CITY OF WEST DES MOINES
STAFF REPORT COMMUNICATION

ITEM: Microsoft DSM 43, 11100 Booneville Road – Approve Major Modification to Site Plan to allow construction of a data center building – Microsoft Corporation – MaM-006238-2023

Resolution: Approval of Major Modification to Site Plan

Sheet Title/Number
LANDSCAPE PLAN OVERALL

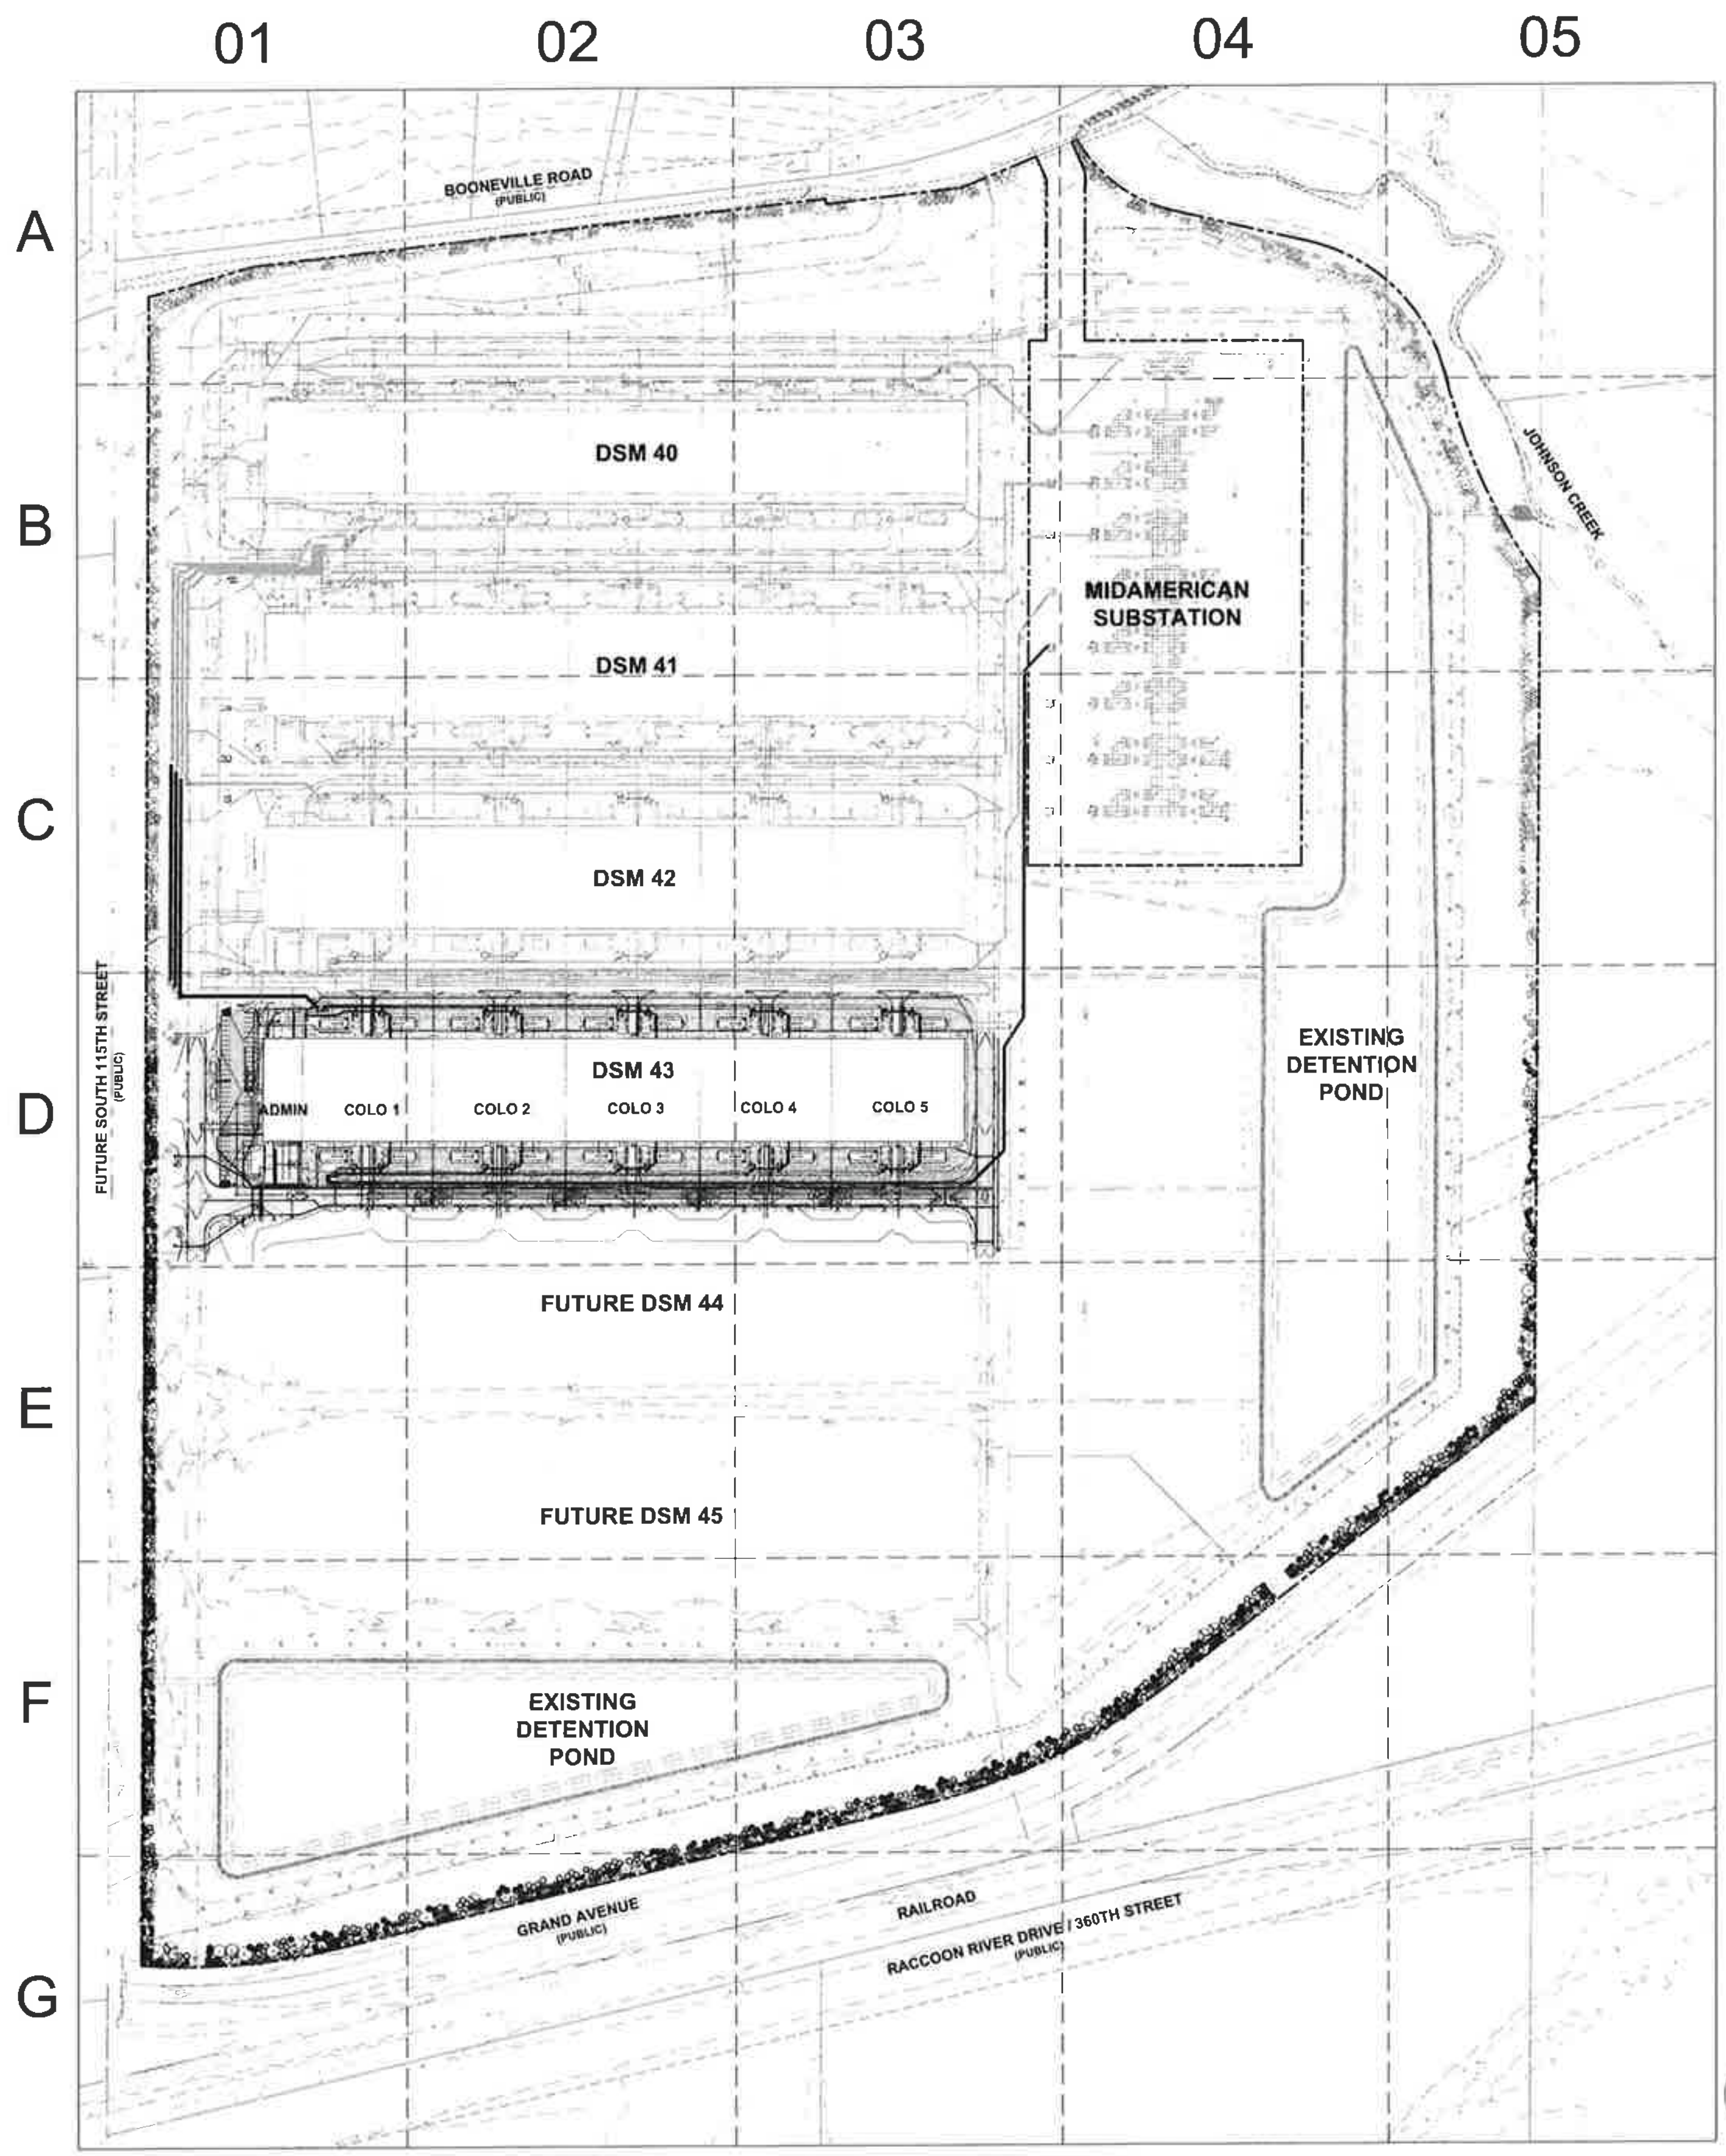
- *Key Development Aspects:*
  1. *Parking Lot Landscaping*: The applicant is proposing to only plant shrubs within the landscape islands in the parking lot instead of the required trees and reduce the number of landscape islands due to security concerns. Also, the applicant is proposing to install gravel in areas around the parking lot and buildings where access to utility structures for maintenance purposes is necessary instead of planting grass. Grass will be planted between the main north/south access road and the parking lot. This was discussed with the Development & Planning Subcommittee as part of the requested approval of DSM 41 and was a compromise between the operational concerns and the code required landscaping (see Development and Planning Subcommittee bullet below). The City Council supported this approach as part of the site plan approval of DSM 41, and the same is being requested of the approval for DSM 42 which is also being considered at the December 27, 2023 Plan and Zoning and January 2, 2024 City Council meetings. The applicant has placed the required parking lot trees in the buffer areas surrounding the site. The areas of gravel in lieu of vegetation around the building's utility structures are screened from public view by the landscape buffer around the site. Staff believes these changes proposed to the landscaping on the site plan meet the intent of the code and are a reasonable accommodation for the specific operational requirements of this project. Recommended conditions of approval that these alternative methods be approved by the City Council have been added.

- *Development & Planning Subcommittee:* On December 19, 2022, the Development & Planning City Council Subcommittee discussed the use of gravel in and around the proposed parking lot and the omission of trees within the landscape islands in the parking lot for this site. The Subcommittee members were supportive of allowing shrubs to replace trees in the parking area in light of security concerns as presented by Microsoft's representative, waiving required landscape islands in the parking areas, and allowing partial use of gravel or paving near utilities for maintenance purposes while requiring the incorporation of vegetation to comply with code for the bulk of the landscaped areas adjacent to parking lots and any area visible from the perimeter of the site.

1. The City Council agreeing to not require landscape islands in the parking lot as required by City Code due to security concerns with trees in the parking lot. Required parking lot trees shall be added to the buffer plantings.

2. The City Council allowing shrubs in lieu of trees to be planted within parking lot islands due to security concerns with trees in the parking lot. Required parking lot trees shall be added to the buffer plantings.

*REQUIRED TREES ARE PROVIDED IN LANDSCAPE BUFFER AND ARE LABELED ON SHEET L-A1-D05 & L-A1-E05
